Suggested Topics for Further Discussion
Regarding Industry's Proposed Approach to
Risk Informing ASME SEC. XI App. G

Approaches Proposed by Industry at 21 August 2008 Meeting

NRC Suggestions for Discussion

NRC Understanding of Industry Proposed “Modified App. G Approach”

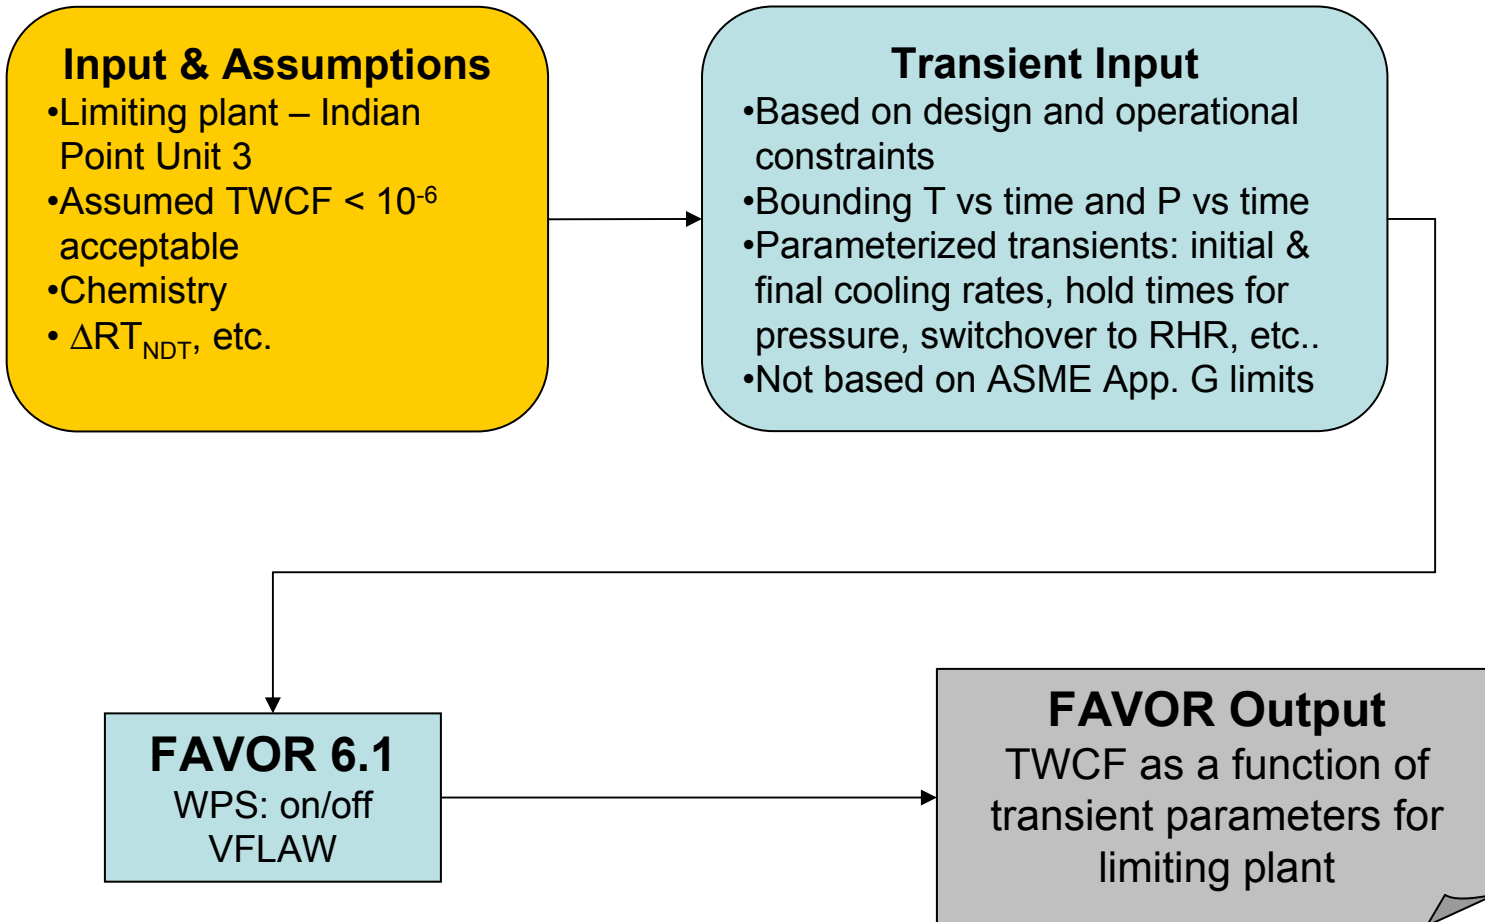
- As summarized in the earlier slides, at the meeting on 21 August we understood two different approaches to risk-informing Appendix G to have been presented. Perhaps this understanding was mistaken. We suggest you discuss how what we have identified as two different approaches (this may or may not be true) both contribute in a consistent and integrated manner toward the risk-informed revision of Appendix G. Also, we suggest you comment on / correct any inaccuracies that you see in our explanation of your two different approaches.
